ENVIRONMENTAL COMMISSION MOTION 20221102-002

Subject: Brodie Oaks Redevelopment PUD, C814-2021-0099

NAME & NUMBER OF PROJECT: Brodie Oaks Redevelopment PUD C814-2021-0099

COMMITTEE MEETING DATE:	November 2, 2022
NAME & NUMBER OF PROJECT:	Brodie Oaks Redevelopment Site Specific SOS Amendment C814-2021-0099
NAME OF APPLICANT OR ORGANIZATION:	Armbrust & Brown (David Armbrust)
LOCATION:	4107 S Capital of Texas Highway
COUNCIL DISTRICT:	5
ENVIRONMENTAL REVIEW STAFF:	Leslie Lilly, Environmental Program Coordinator, (512)535- 8914, Leslie.lilly@austintexas.gov
WATERSHED:	Barton Creek Watershed/Barton Springs Zone
REQUEST:	In response to Council Resolution 20221011-076, consider a site-specific amendment to City Code Chapter 25-8, Subchapter A, Article 13 (Save Our Springs Initiative), as minimally required to allow for limits to impervious cover as proposed in application C814-2021-0099 for the Brodie Oaks PUD development. The proposed site-specific amendment should be included as part of the discussion and consideration of the Brodie Oaks PUD development.
STAFF RECOMMENDATION:	Staff recommended with conditions

Exhibit G: Grading Plan

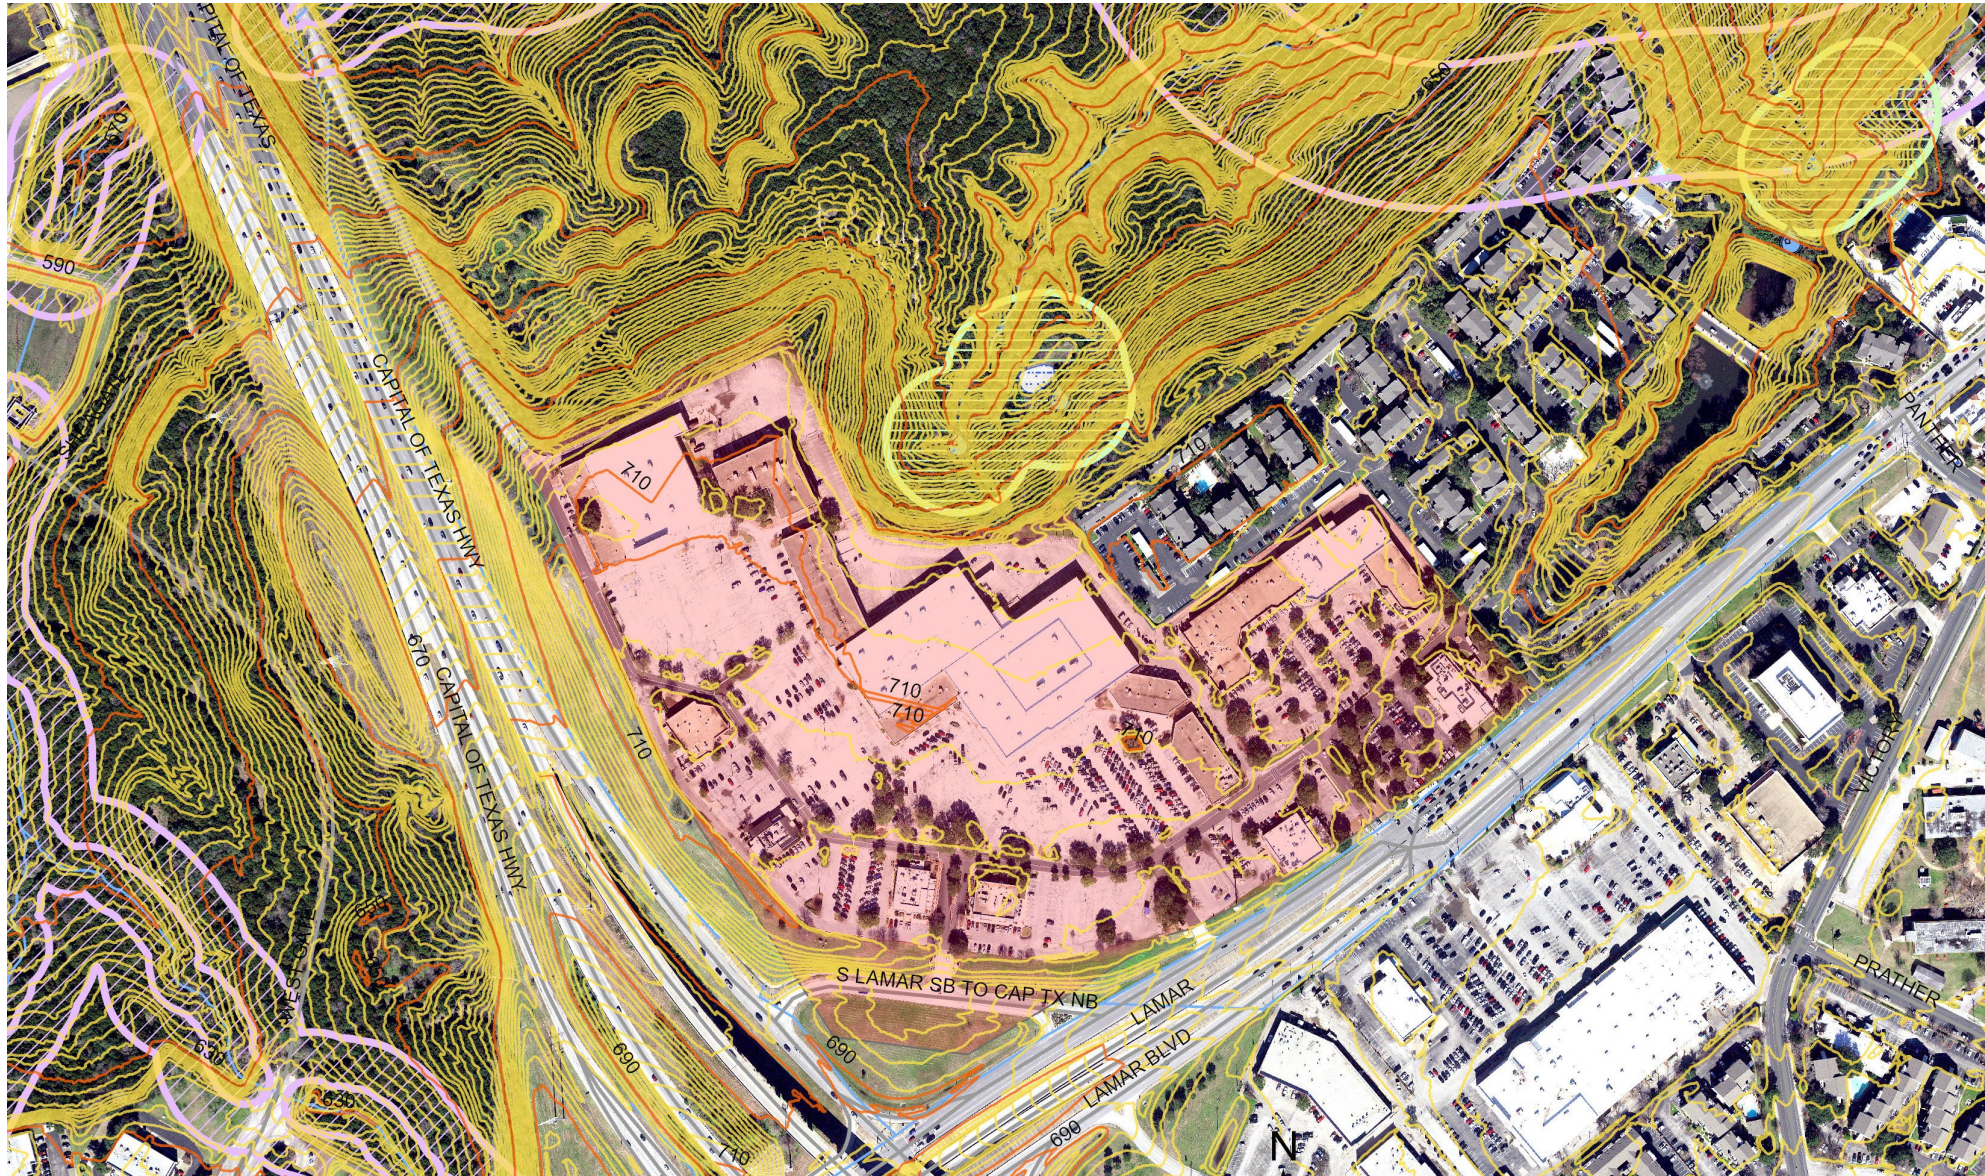
- 25-8-341 shall be modified to allow cut not to exceed a maximum of fourteen (14) feet as indicated on Exhibit G.
- 25-8-342 shall be modified to allow fill not to exceed a maximum of fourteen (14) feet as indicated on Exhibit G.
- 25-8-281 shall be modified to allow encroachment into CEFs as indicated on Exhibit F.

Exhibit F: Environment

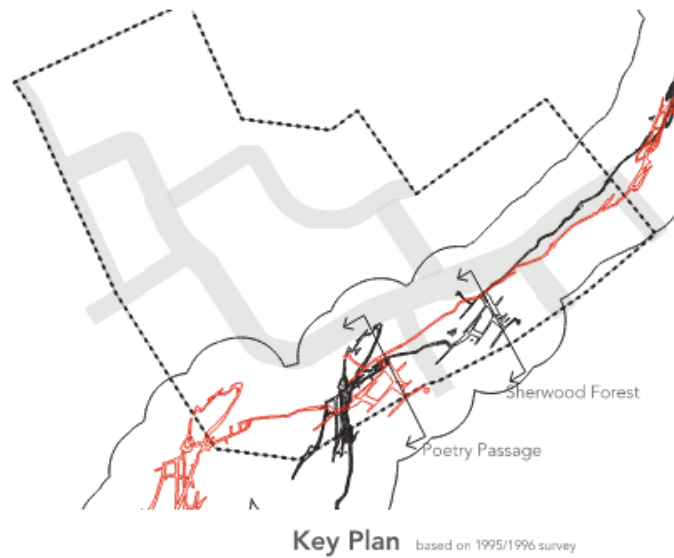
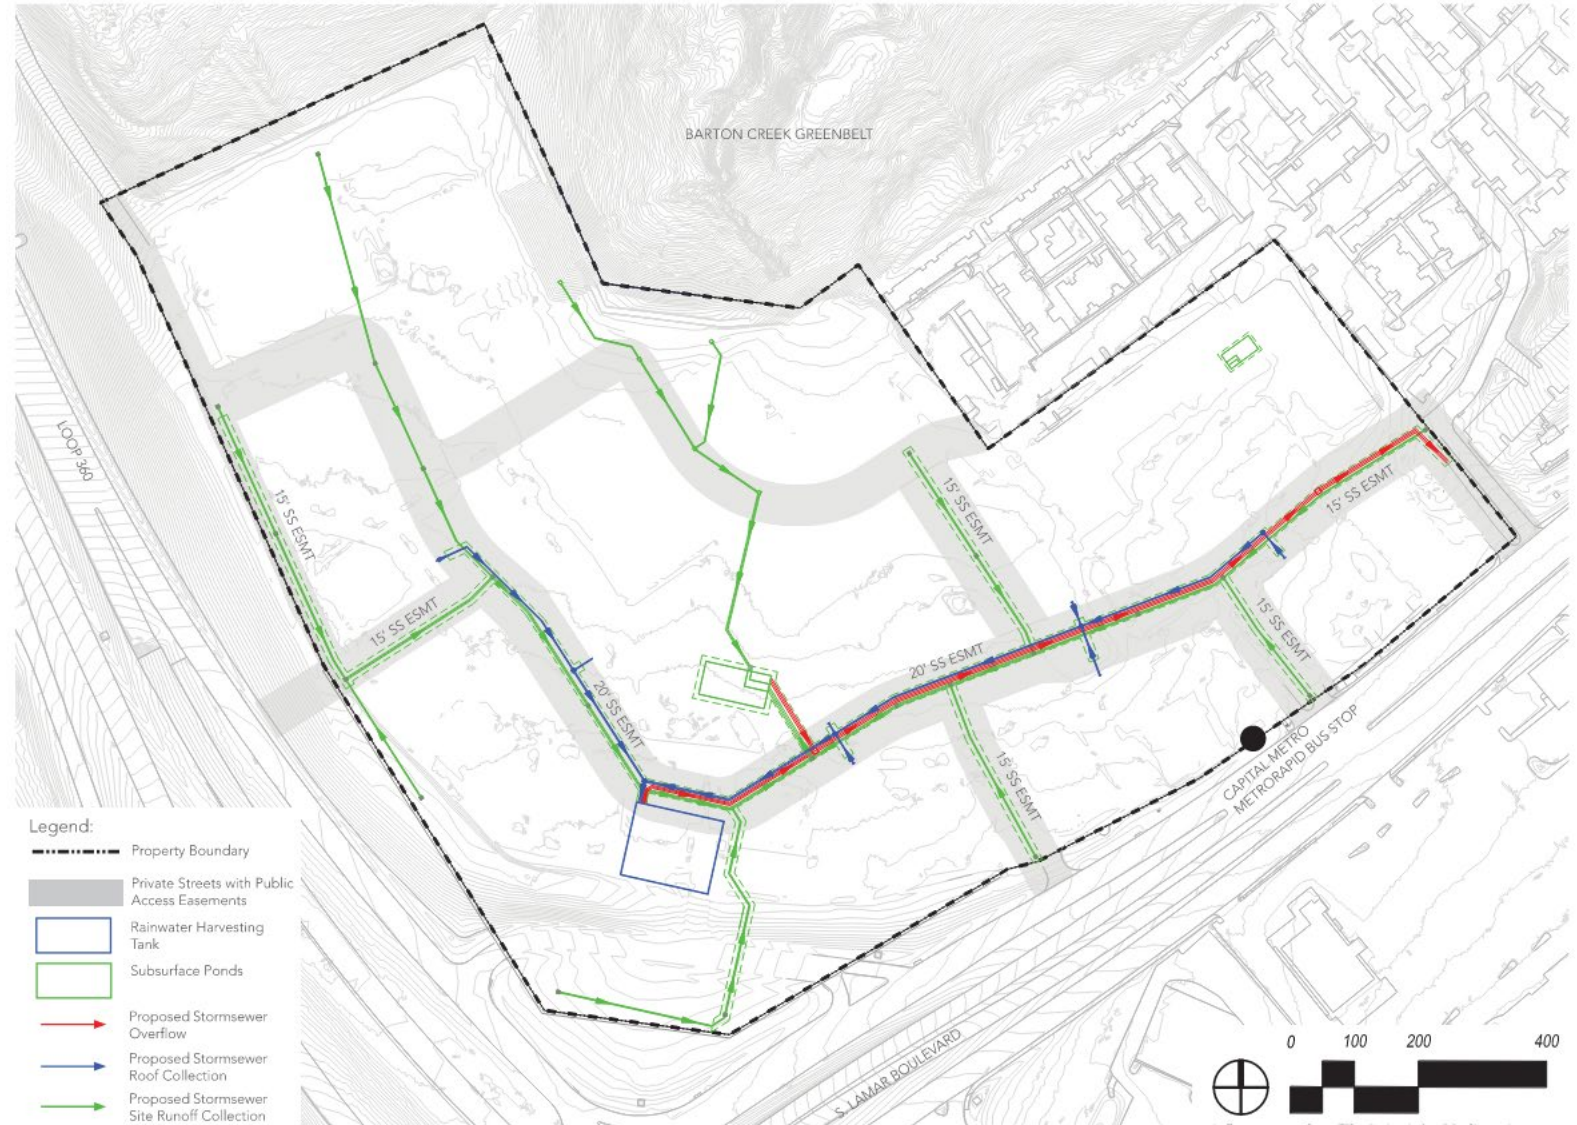
1. Modify CEF setback for S-1/S-2
2. Impact to Airman's Cave CEF setback is limited of up to 80' with conditions
3. Protective fencing for CEFs
